Safety Evaluation Report

Renewal of the Facility Operating License for the Rhode Island Nuclear Science Center Reactor

License No. R-95
Docket No. 50-193

United States Nuclear Regulatory Commission

Figure 4-6 Forced Flow ONB Results

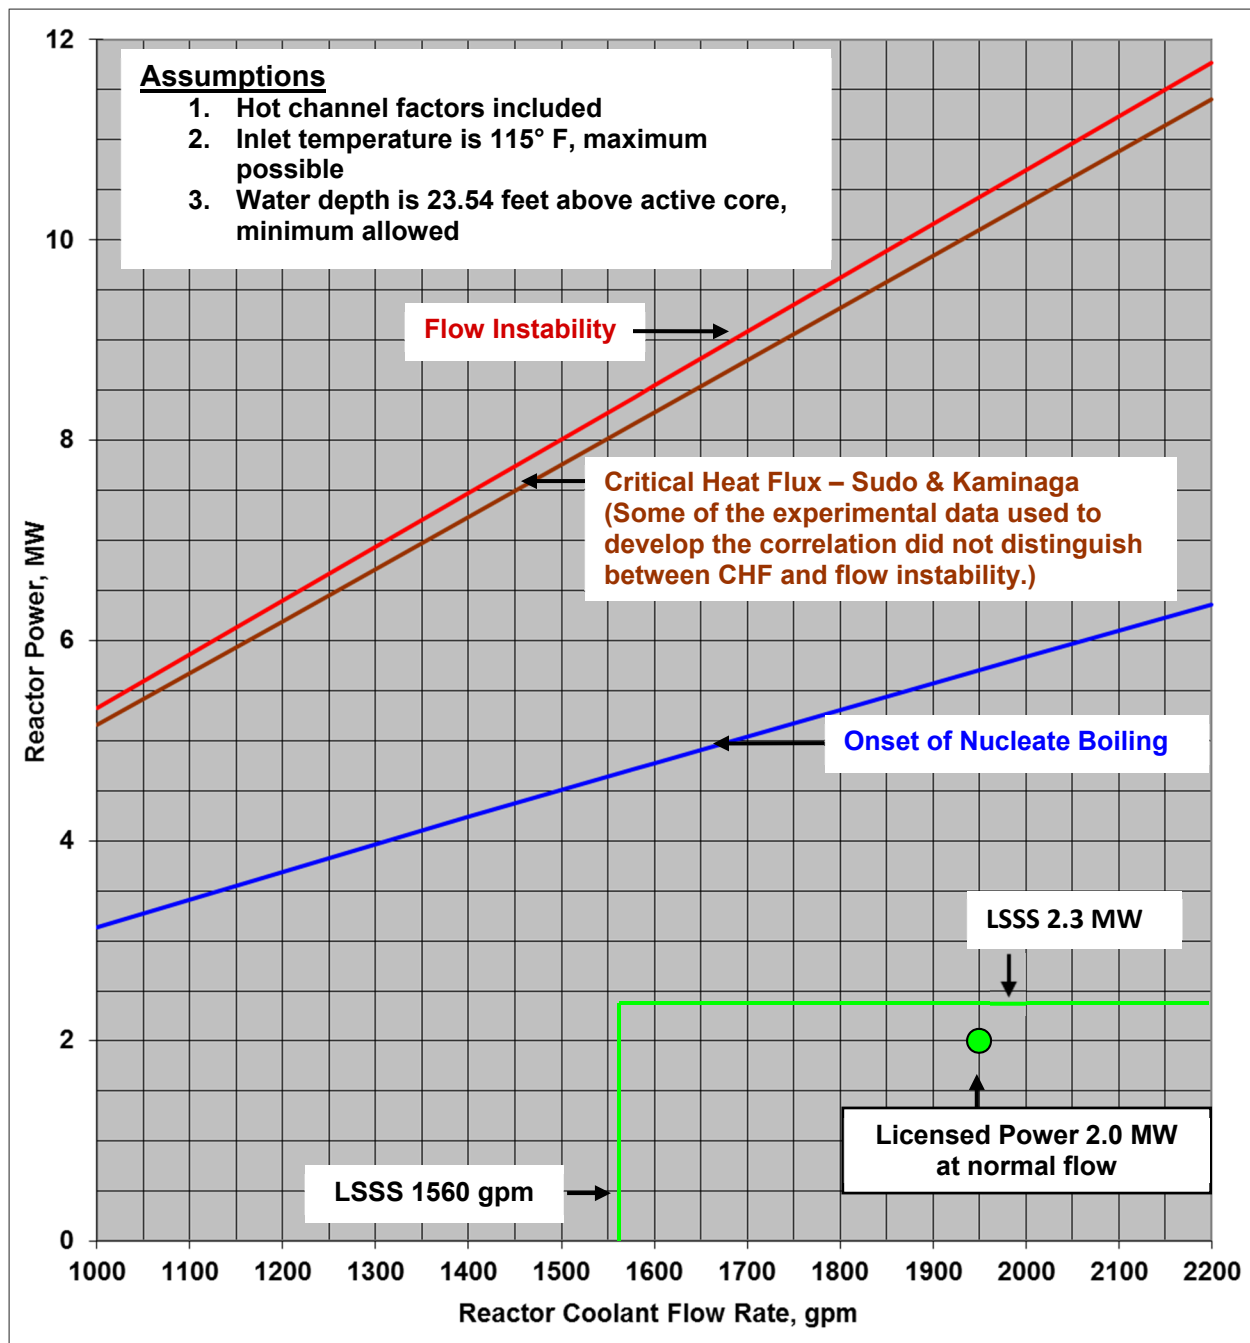
There are 14 fuel assemblies in the analyzed core. Each has 22 fuel plates, for a total of 308 plates. The highest power fuel plate is the one immediately adjacent to the beryllium reflector in assembly D6. PLTEMP/ANL was used to determine the flow rate in the limiting channel as a function of flow rate through the reactor flow meter. The limiting channel for the analysis is one that is between two fuel plates of the same fuel assembly. The PLTEMP/ANL analysis shows that ONB occurs when the power in the plate between the two half channels is at 22.80 kWt. The analysis of the power distribution in the equilibrium core shows that when the reactor is operating at 2.0 MWt, the power in the limiting plate is 9.653 kWt. Thus, 22.80 kWt corresponds to reactor operation at 4.72 MWt. Figure 4-6 identifies the power and flow conditions in relation to ONB. The LSSS proposed for the RINSC are well within the power/flow region that has significant margin to ONB, which is well below the departure from nucleate boiling conditions. The NRC staff has also reviewed the supplied analysis which includes a calculation of the estimated cladding temperature. Using geometry and properties consistent with the fuel design, the NRC staff estimates that the increase in fuel temperature above the cladding temperature is approximately 3.5 °C (6.3 °F). The NRC staff finds that the forced flow analysis is at temperature and coolant elevations that are conservative with respect to the actual LSSS setpoints, and thus are acceptable assumptions.

**Figure 12-1 Rhode Island Atomic Energy Commission Organization Chart
(Reproduced from Figure 6-1 of TS [Ref. 60])**

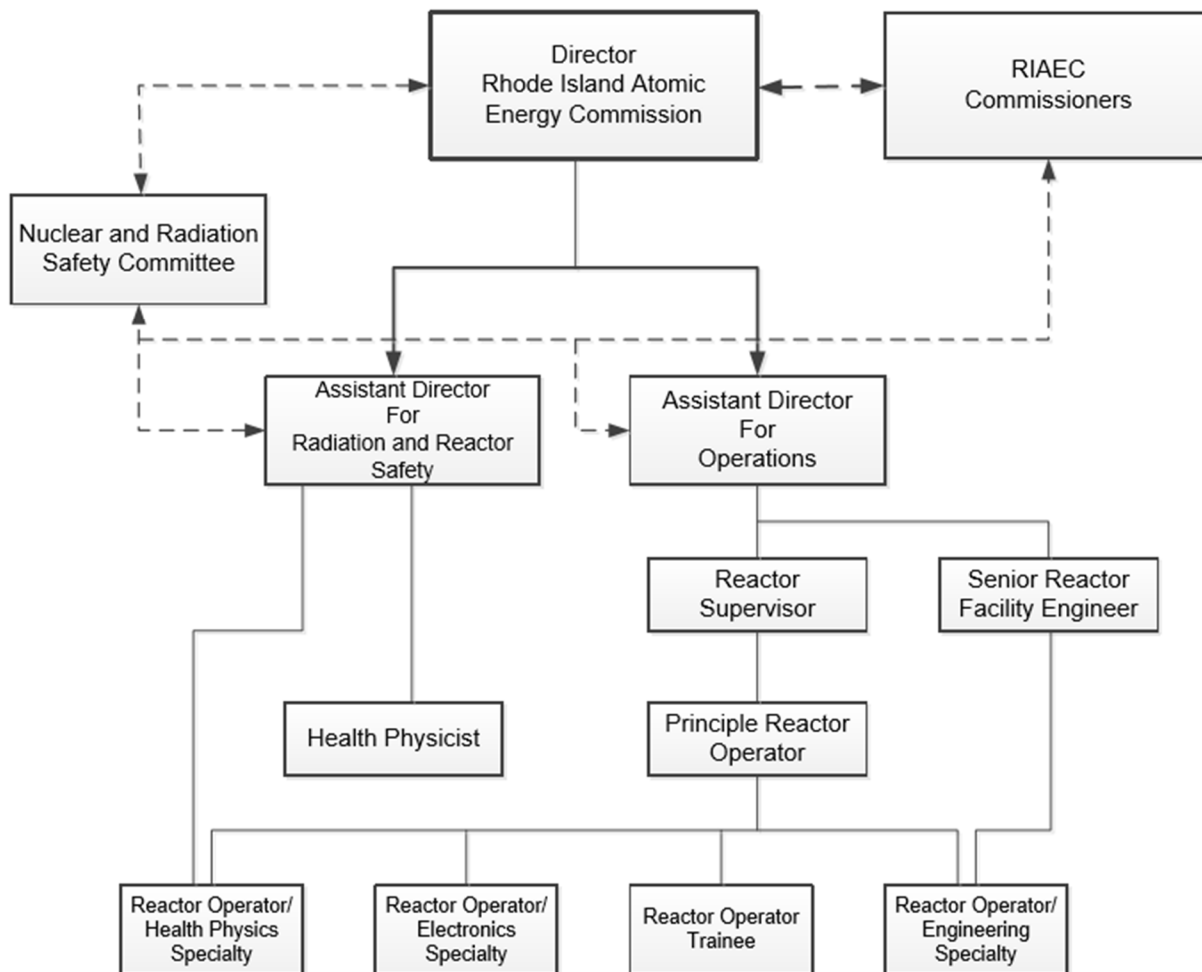
TS 6.1.1 establishes the organizational structure of the RINSC staff. This specification helps ensure that the RINSC organization structure is properly delineated and understood. The staff notes that on TS Figure 6.1 (SER Figure 12-1) solid and dotted lines are not defined. The licensee confirmed (Ref 58) that the lines are defined as shown in ANSI/ANS-15.1-2007, where solid lines are reporting lines and dotted lines are communication lines. The RINSC organizational structure described in this specification and shown in RINSC TS Figure 6.1, is consistent with the guidance in ANSI/ANS-15.1-2007, Section 6.1.1, as accepted in NUREG-1537. Based on the information above, the NRC staff concludes that TS 6.1.1 is acceptable.

Figure 13-2 Flow rates for the LOFA

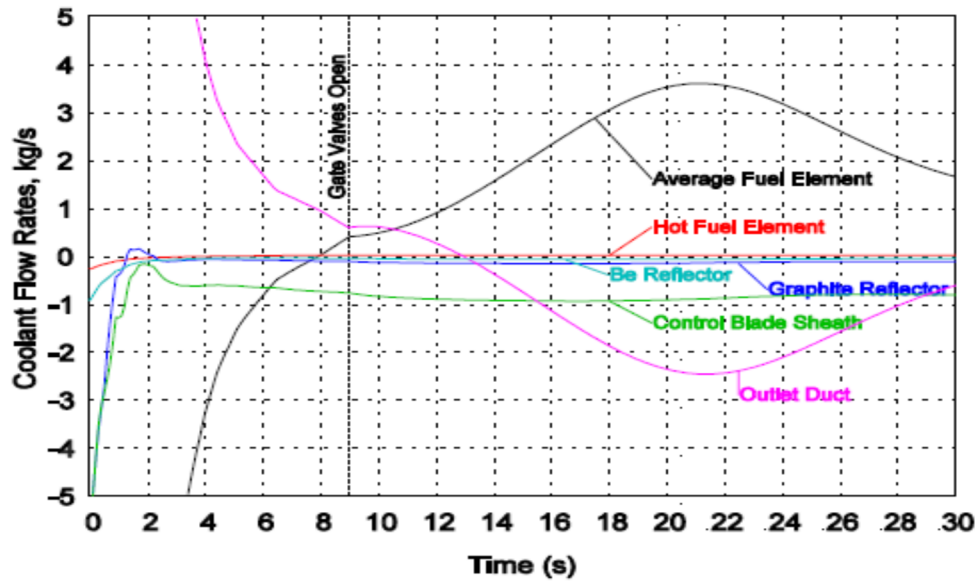
The NRC staff noted that the operating parameters cited in SAR Section 13.2.4.1 LOFA analysis did not match the limiting conditions in the TSs. In the response to RAIs 13.18 and 13.19 (Ref. 3), the licensee described the results of new LOFA analyses using RELAP5. In these analyses, the licensee used the trip setpoints values that are consistent with the TS LSSS for FC (TS 2.2.2). In these analyses, the licensee listed the initial conditions (limiting trip values), pump flow coast down, limiting conditions on the reactivity insertion and its timing, and the timing when the NC gate valve opens. For the case when the gate valves open (9 second after trip), the licensee's calculations show a maximum fuel clad temperature of 115.62 °C (240.12 °F), with a peak fuel temperature of 115.73 °C (240.31 °F) and a coolant saturation temperature of 115.90 °C (240.62 °F). These results indicate the coolant peak temperature to be close to the onset of sub-cooled boiling. The licensee added that at a higher initial power level, if sub-cooled boiling occurs, coolant heat transfer would increase and would limit the fuel and clad temperature rise.

For the case when the two gate valves fail to open, the licensee stated that the peak clad temperature is slightly lower (115.61 vs. 115.62 °C), and occurs at the same timeframe (at 9.41 seconds). The reason for the lower peak temperature when the gate valves do not open can be attributed to the changes in the amount of flow that is drawn out of the outlet duct. As shown in Figure 13-2, the flow rate near 9 seconds after the event initiation indicates that the outlet duct upward flow rate immediately after the gate valves open is slightly higher than what would be obtained by extrapolating the flow rate from before the gate valves open. The slightly increased coolant being drawn out of the outlet plenum causes slightly less up-flow through the fuel channels and slightly higher temperatures in the fuel channels than if the gate does open. However, it is desirable to have the gates open for long-term NC cooling.

The NRC staff has reviewed the new LOFA analysis and finds that the assumptions used in the analysis are acceptable. The licensee's steady-state FC T-H analysis (Ref. 3) establishes initial conditions that are slightly different than those used in the LOFA analysis. Table 13-9 summarizes the initial conditions used in the LOFA and those used in the steady-state T-H analysis.
